# Access Compliance Report

## Public Rights-of-Way

### (Curb Ramps)

Intersection ID: 42368	Main Street: FAIRVISTA_DR	Cross Street: HIGHLAND_CREEK_PY	Location: SW
ADA ID: EBA2AD10490E	Ramp Type: PerpDiag	Initial Pass/Fail: Fail	Overall Compliance: No
		Severity Score: 12.5

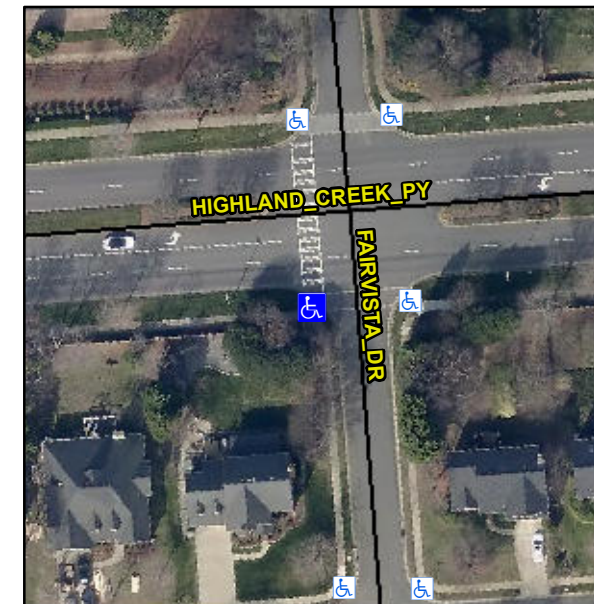
Compliance	Description	Data	Compliance	Description	Data
N/A	Ramp Length (in)	72.0	No	Ramp Slope (%)	8.5
Yes	Ramp Width (in)	48.0	Yes	Ramp XSlope (%)	2.0
N/A	Flare Type LT	N/A	N/A	Flare Type RT	N/A
N/A	Flare Slope LT (%)	N/A	N/A	Flare Slope RT (%)	N/A
N/A	Flare Traversable LT?	N/A	N/A	Flare Traversable RT?	N/A
N/A	Landing Length (in)	N/A	N/A	DWS Provided?	N/A
N/A	Landing Width (in)	N/A	N/A	DWS Contrast?	N/A
N/A	Landing Slope (%)	N/A	N/A	DWS Length (in)	N/A
N/A	Landing X Slope (%)	N/A	N/A	DWS Full Width?	N/A
N/A	Landing Curb? (Y/N)	N/A	N/A	DWS Offset (in)	N/A
N/A	Shared Landing?	N/A			
N/A	Gutter Ponding?	N/A	N/A	Gutter Slope (%)	N/A
N/A	Gutter Lip Ht (in)	N/A	N/A	Gutter X Slope (%)	N/A
N/A	Painted X Walk1?	Yes	N/A	Painted X Walk2?	Yes
	X Walk 1 Direction	To E		X Walk 2 Direction	To N
N/A	X Walk 1 Width (in)	96.0	N/A	X Walk 2 Width (in)	112.0
	X Walk 1 Slope (%)	3.8		X Walk 2 Slope (%)	7.1
	X Walk 1 X Slope (%)	6.7		X Walk 2 X Slope (%)	0.8

N/A	Ramp inside XWalk1?	Yes	N/A	Ramp inside XWalk2?	Yes
	Road Slope (%)	2.0	N/A	Clear Space?	N/A
	Road X Slope (%)	8.3	N/A	Clear Space to XWalk (in)	N/A
N/A	Any Obstructions?	N/A	N/A	Storm Grate/Utility Hazard?	N/A
	Obstruction Type			Storm Grate/Utility Type	
		N/A			N/A
		Yes		Surface Condition? (G/P)	Good

**Remove & Replace Curb Ramp With Two New Directional Ramps or Equivalent.**

**R304.2.2**
